Section 4.55(1A) Modification Application
to SSD 8209-
Site 4A, Oakdale South Industrial Estate,
Kemps Creek

Statement of Environmental Effects
Site 4A, Oakdale South Industrial Estate, Kemps Creek

Project Name _____ **Costco Mod 1**

Figure 25: Proposed Rainwater treatment plant room as notated and clouded in red.

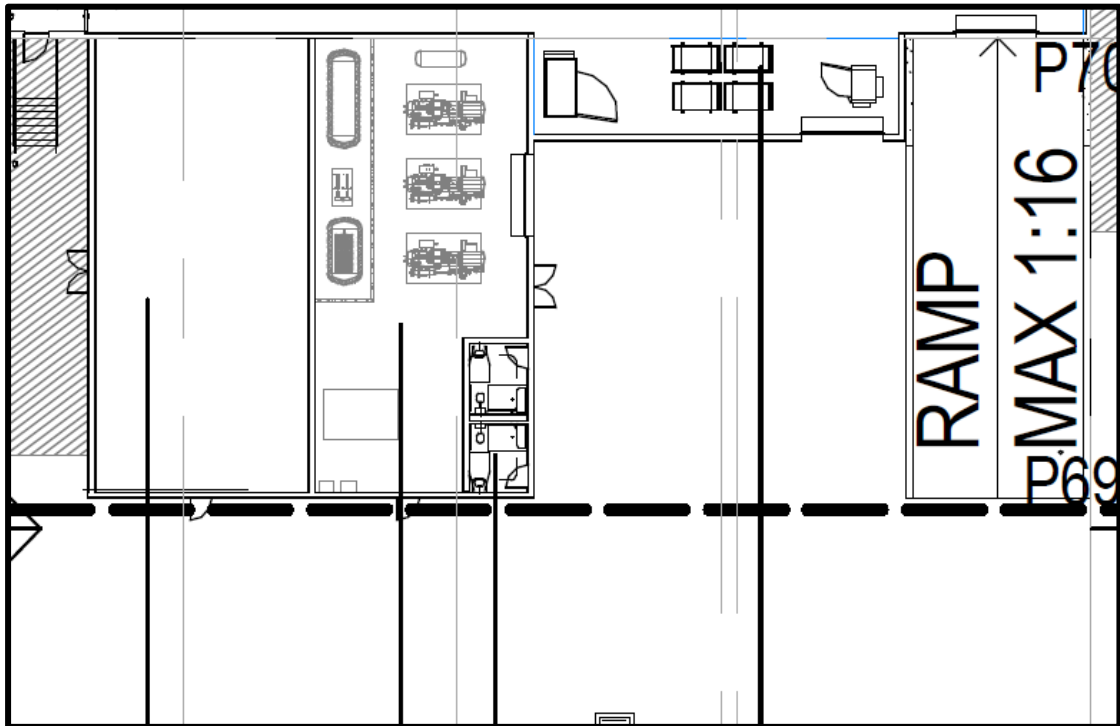
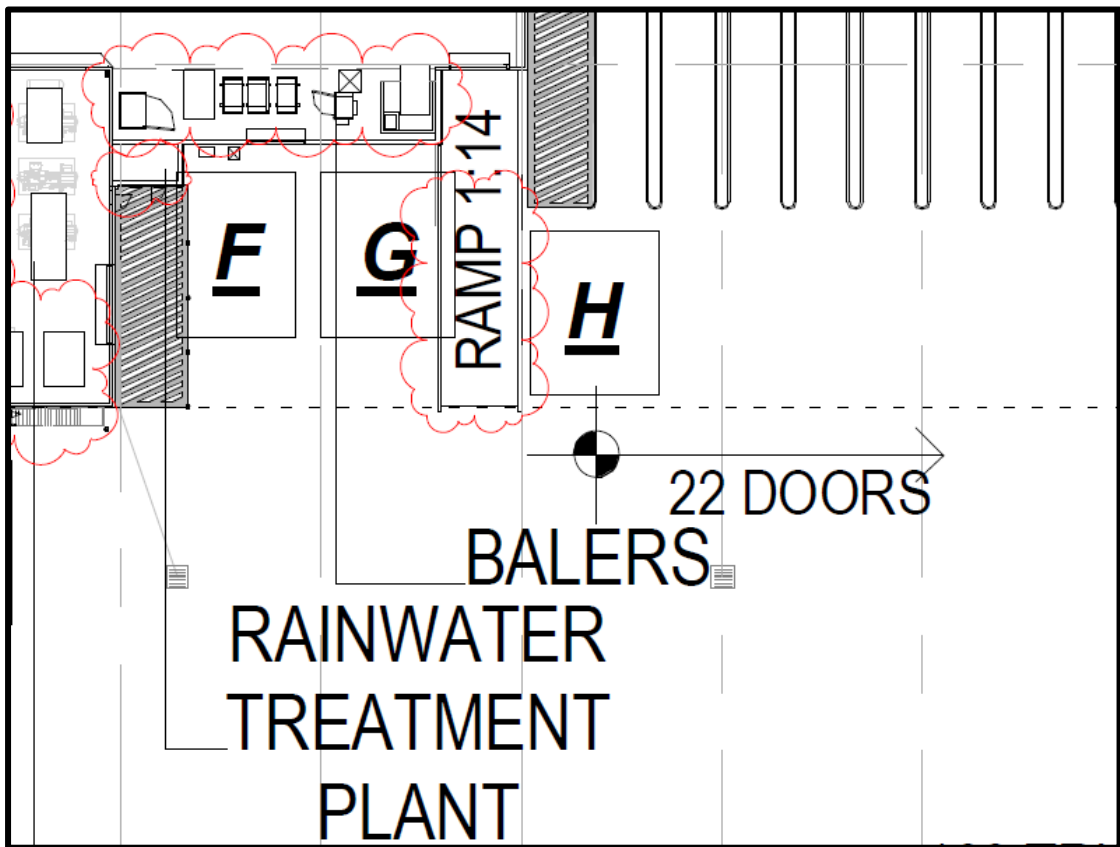
installation of rain water treatment plant room added to eastern external elevation of baler room as denoted as **(F)** on architectural plans.

Figure 27: Proposed lowered roof over Baler room as notated and clouded in Red.

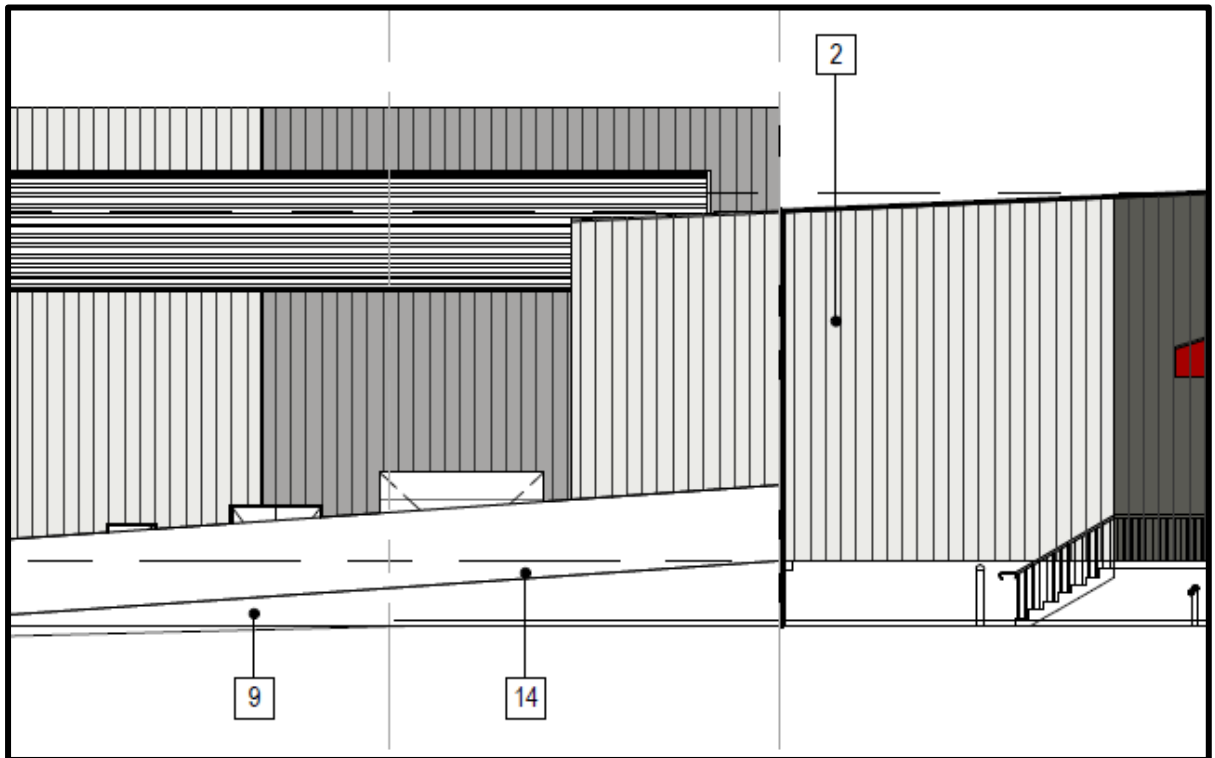
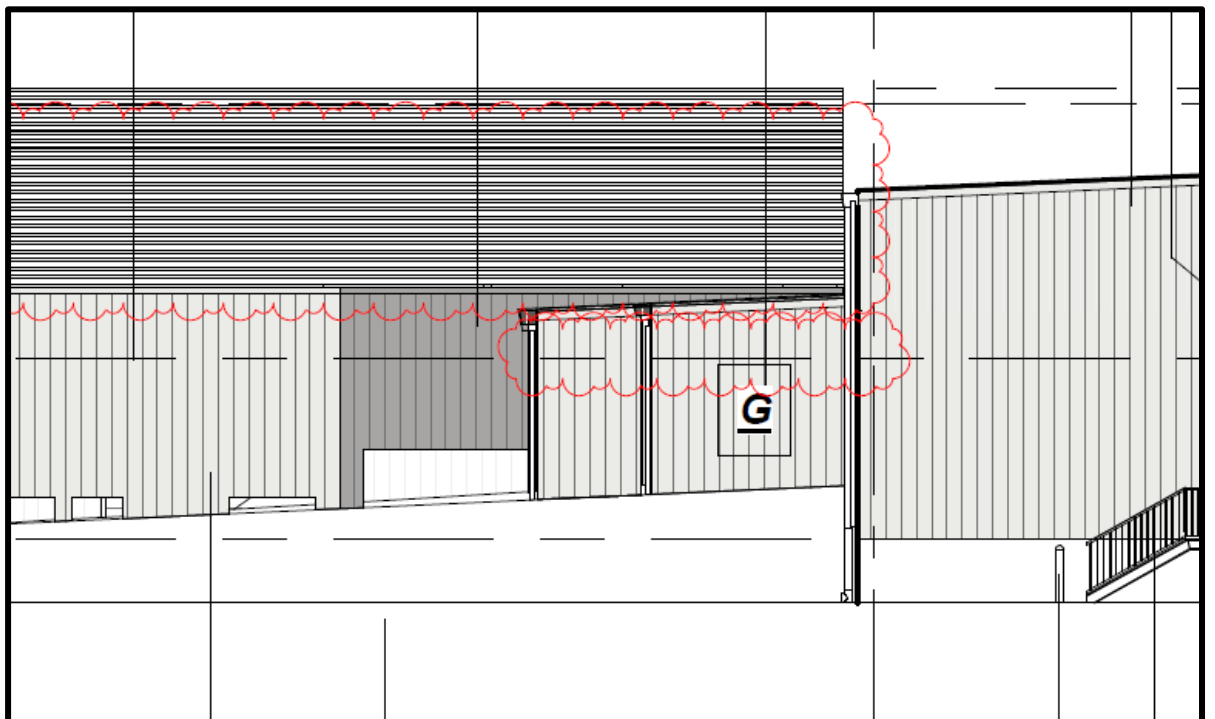
Extension of baler room and lowering of roof height over, located along the eastern external elevation and as denoted as **(G)** on architectural plans.

Figure 29: Proposed Baler room Ramp – Eastern elevation (South End) notated and clouded in red.

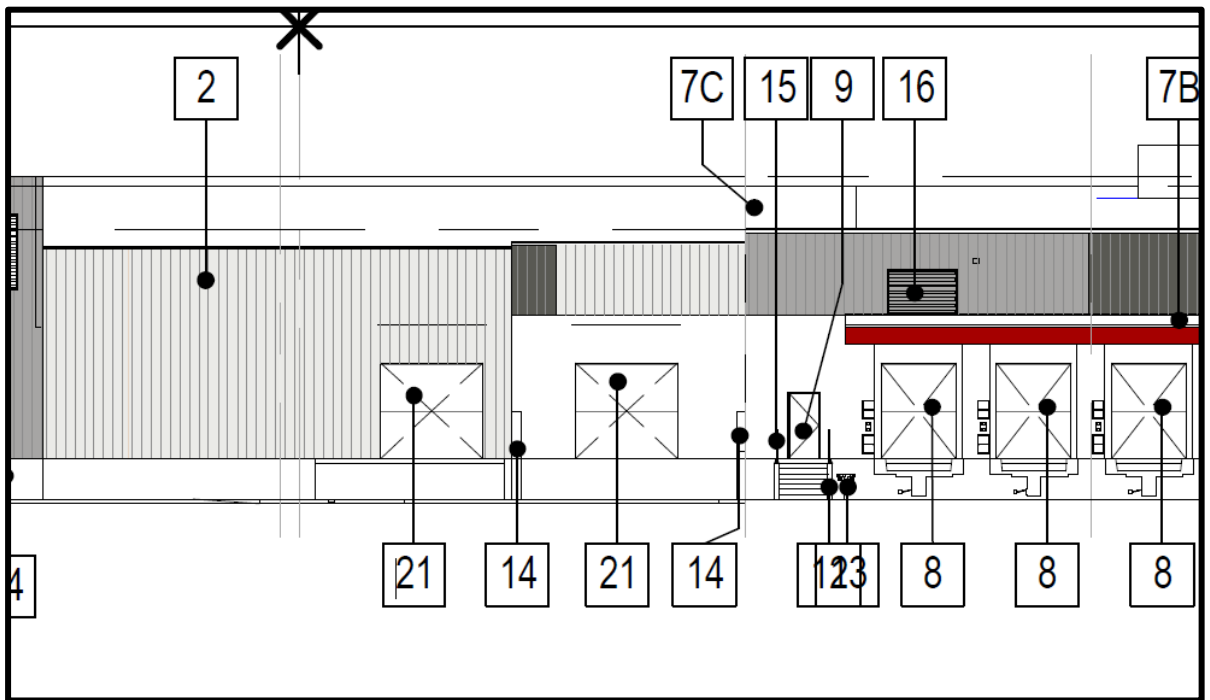
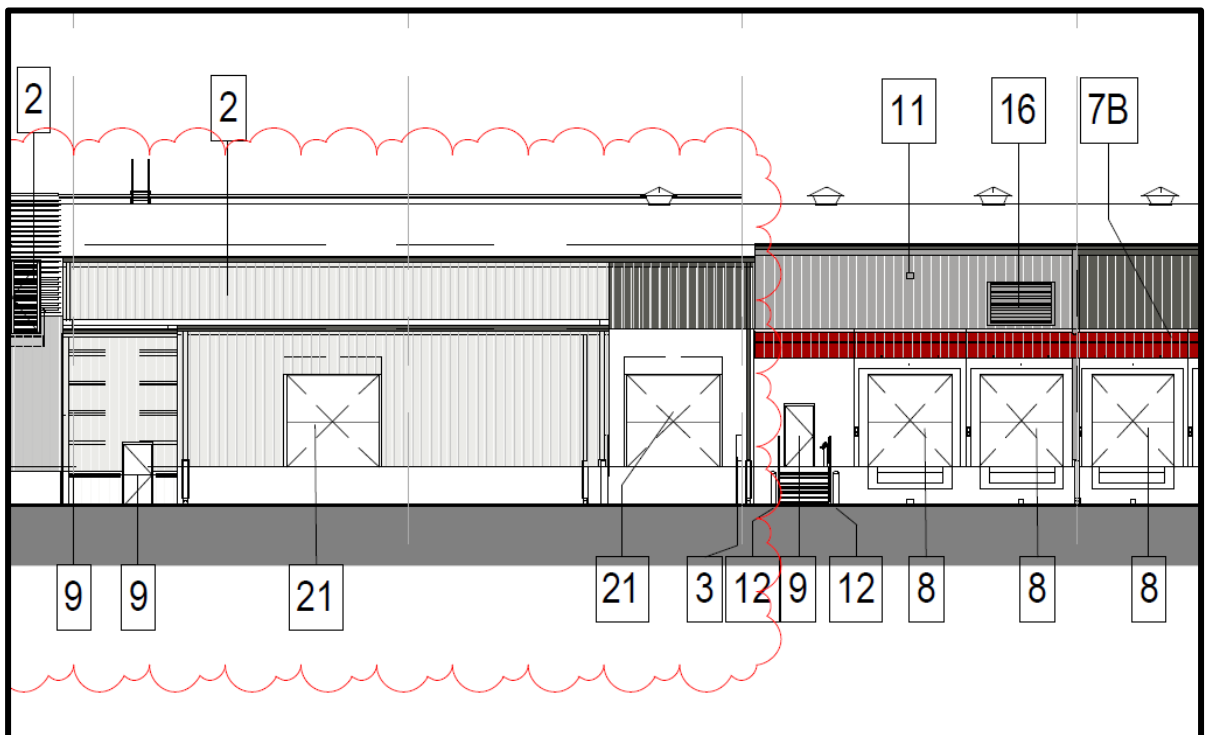
The reduction of the ramp width (adjoining baler room). Refer to eastern elevation and notation marked as **(H)** on architectural plans and referenced in **Figure 28 & 29** in **Appendix A**.

Figure 31: Proposed driveway relocation as notated and clouded in red.

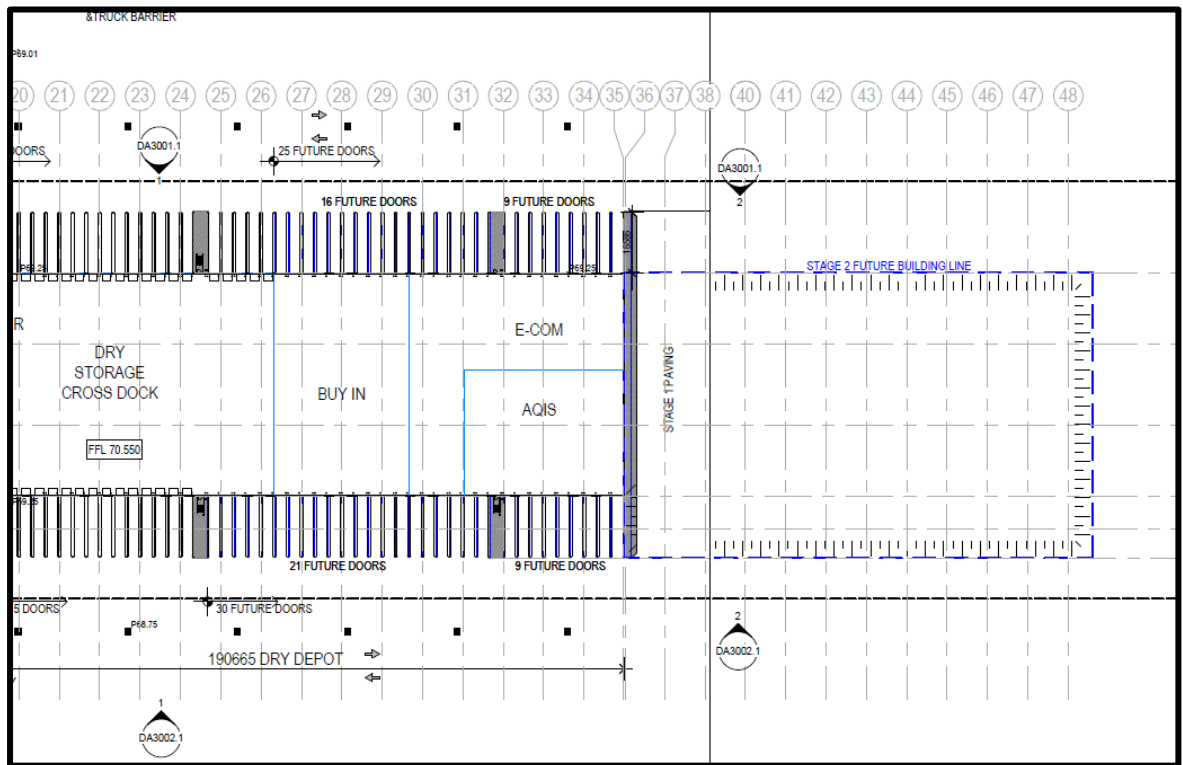
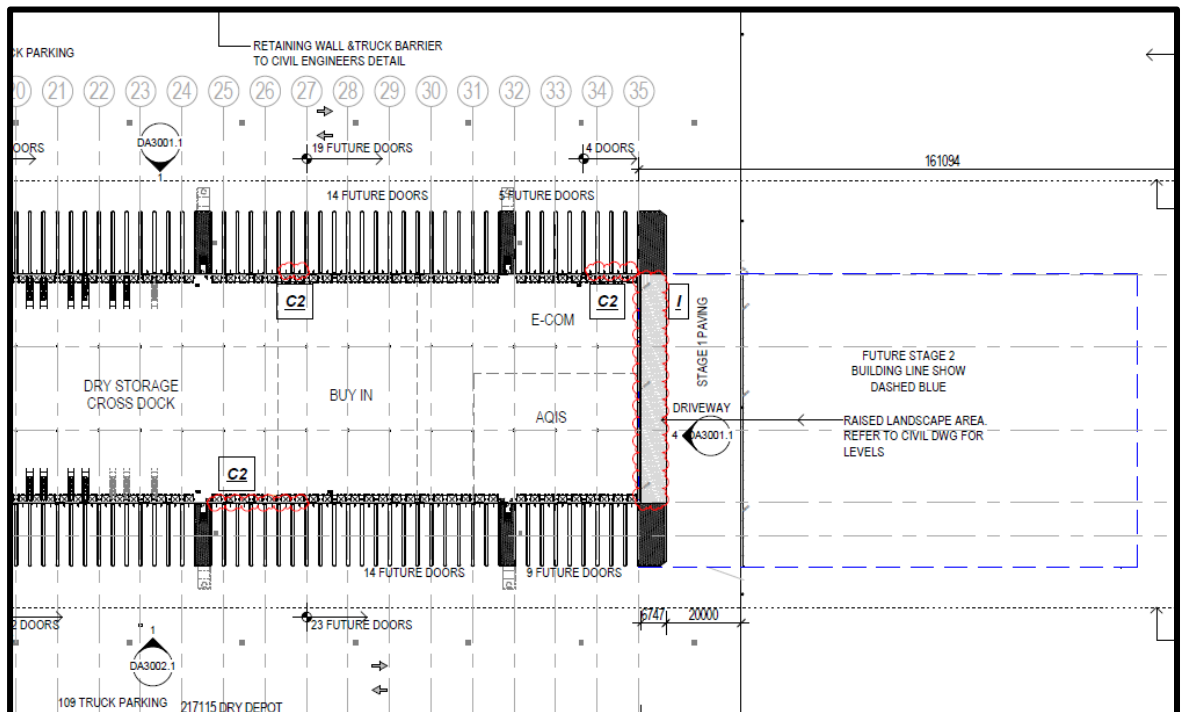
Provision of driveway at north end of dry depot (northern elevation adjacent E-com and AQIS Depot area). Proposed Batter added against building and revised raised landscaped area as denoted as **(I)** on architectural plans.

Figure 35 – Freezer layout revised and demising wall as notated and Clouded in Red.

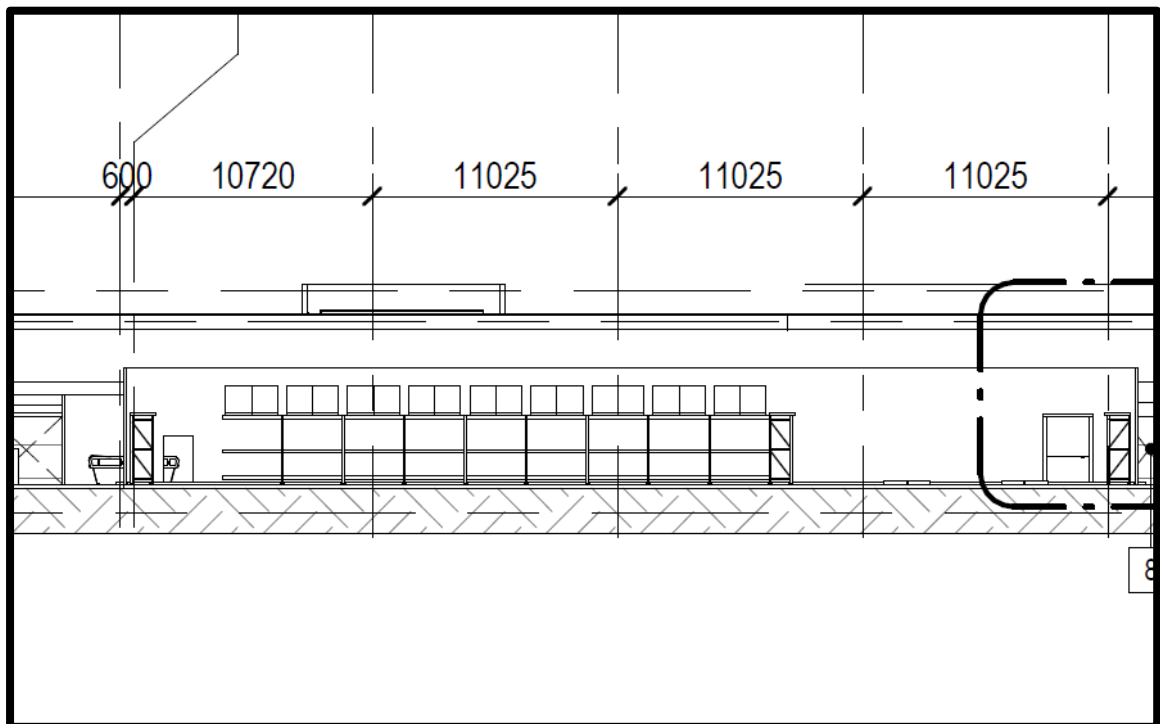
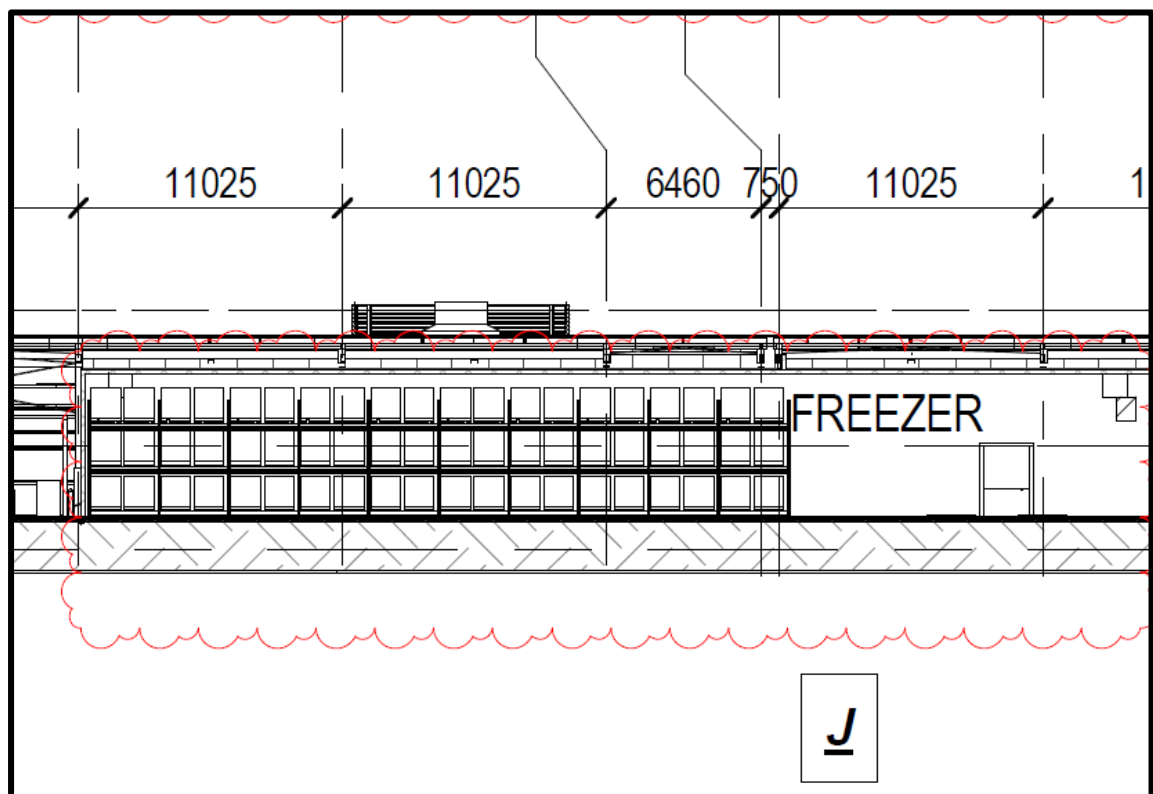
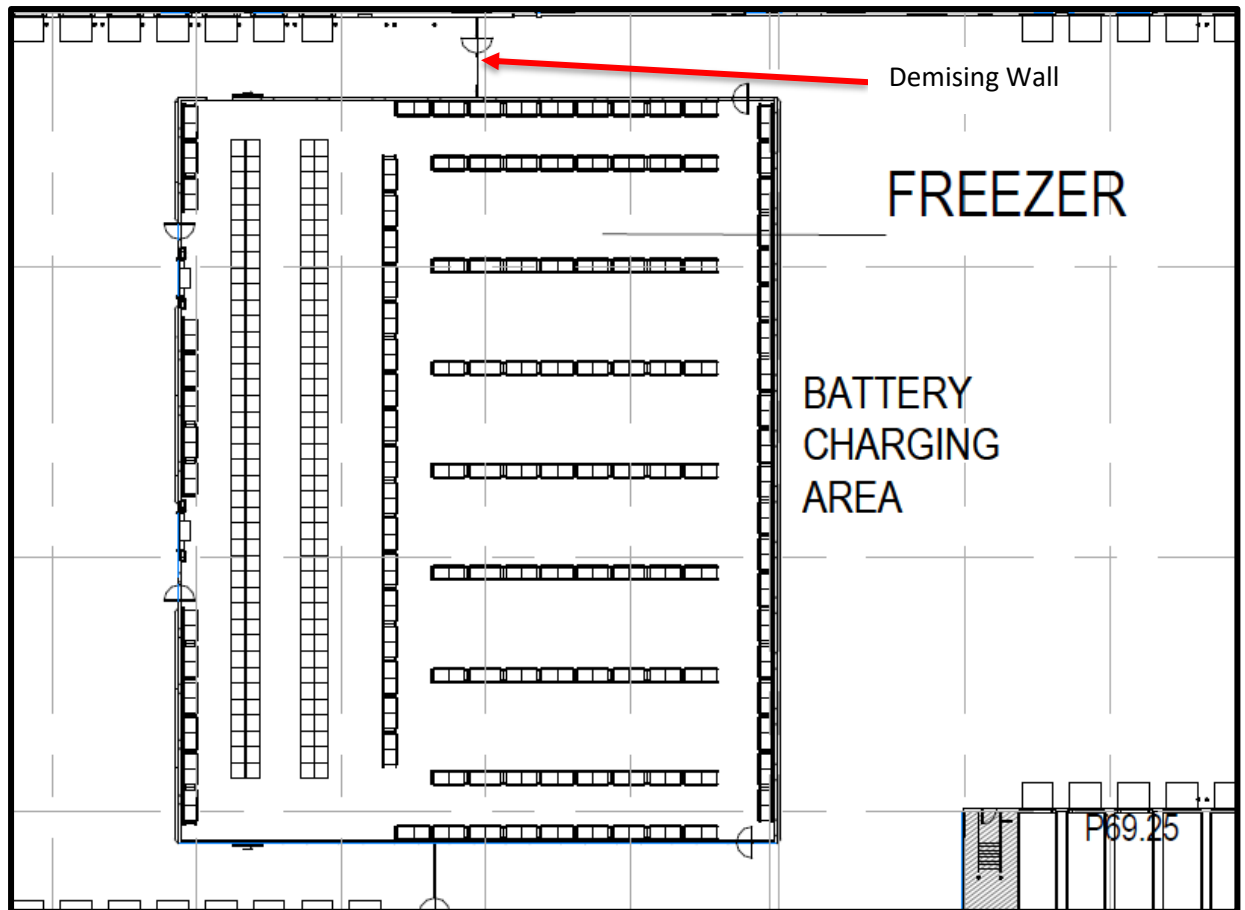
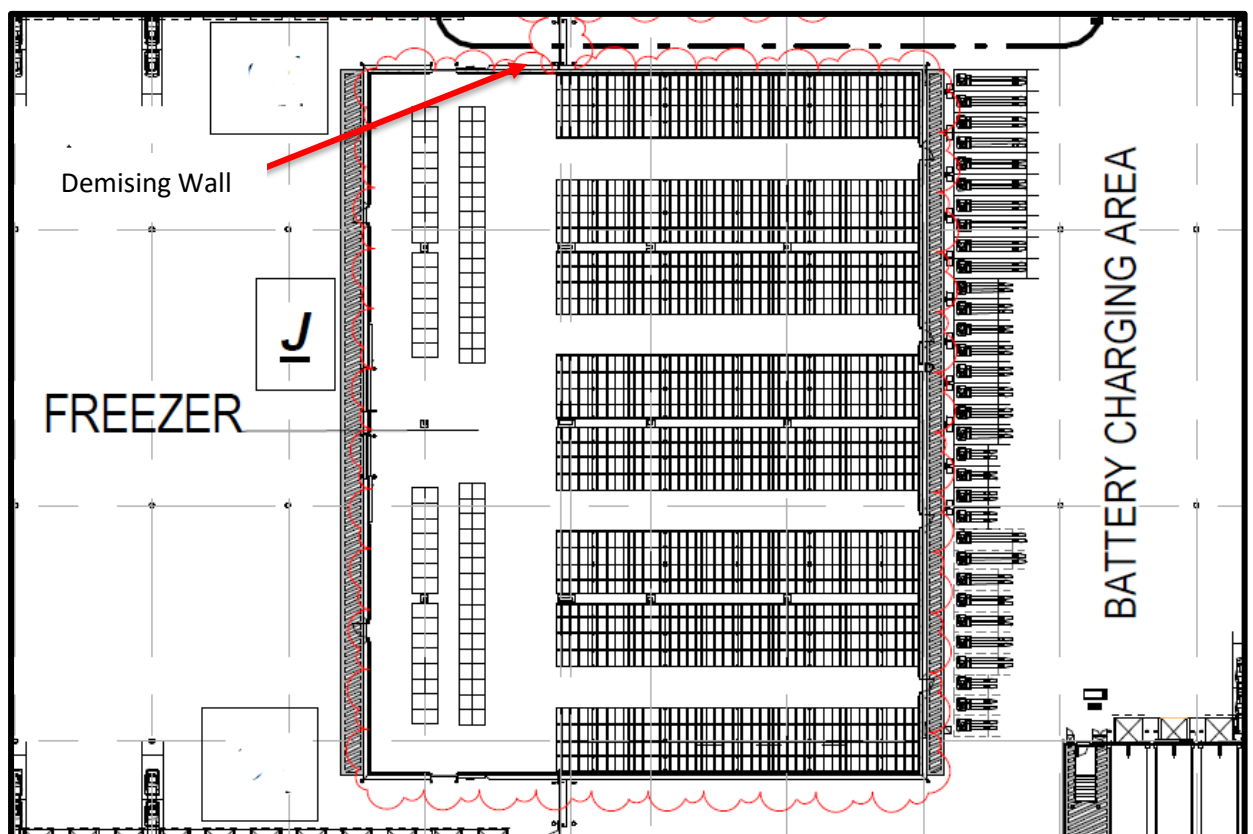
Reconfiguration of Freezer layout and location within Depot and demising wall between dry and wet docks (west) relocated accordingly as denoted as **(J)** on architectural plans.
